PUBLIC MEETING TOWN OF HUDSON OCTOBER 14, 2020

DEWEY & FRIENDS SITE PLAN

SITE PLAN APPLICATION SP#09-20

Re: Town of Hudson Planning Board Review
Dewey & Friends Pet Resort Site Plan, 153 Lowell Road
Tax Map 204, Lot 2; Acct. #1350-953
Reference No. 03-0249.1950

FIELD BOOK: 1239	DRAWING NAME: 3889-SITE-F081	3889	1 OF 22
DRAWING LOC: J:\3000\3889\DWG\SITE	File Number	Sheet

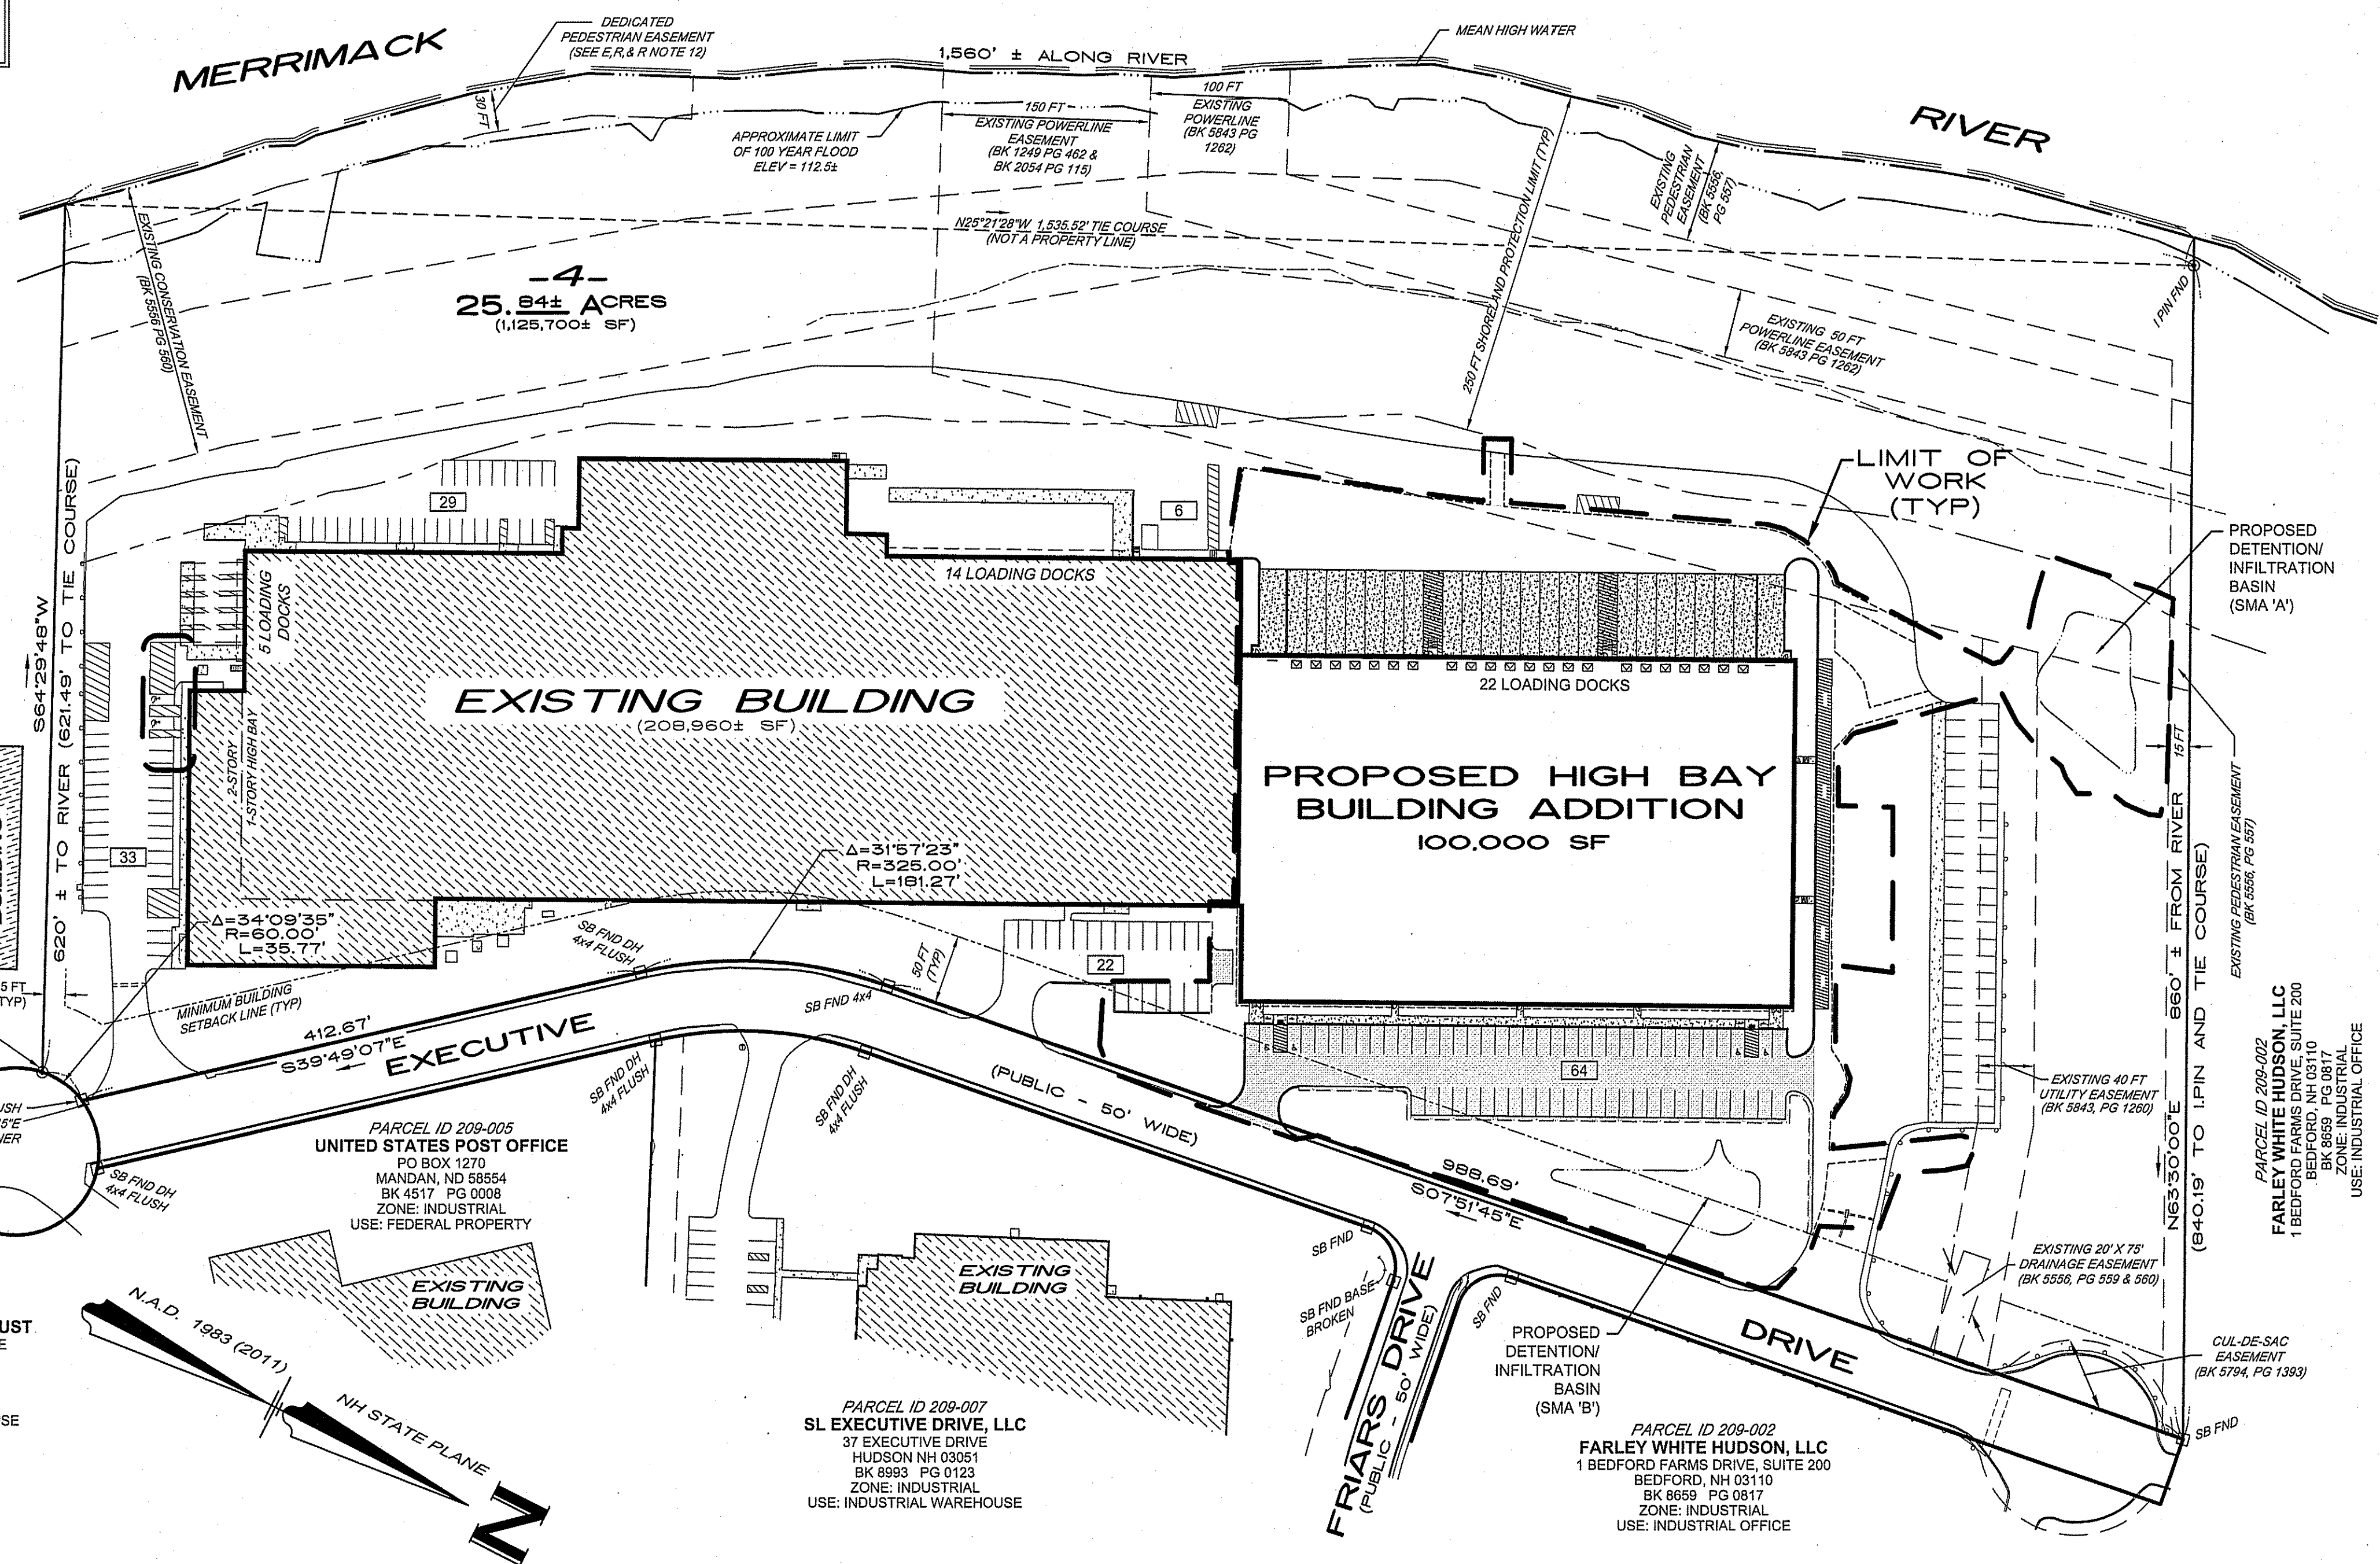
j. HR 290-7.B.16. The applicant has noted on sheet 2 of 22 that snow removal is to be placed in open areas of the site as shown on sheet 3 of 10. This note should be corrected with the appropriate sheet number reference, and proposed snow storage locations should be shown on the plans.

Note #25 has been corrected and snow storage areas have been added to Sheets 9 & 10 of 22.
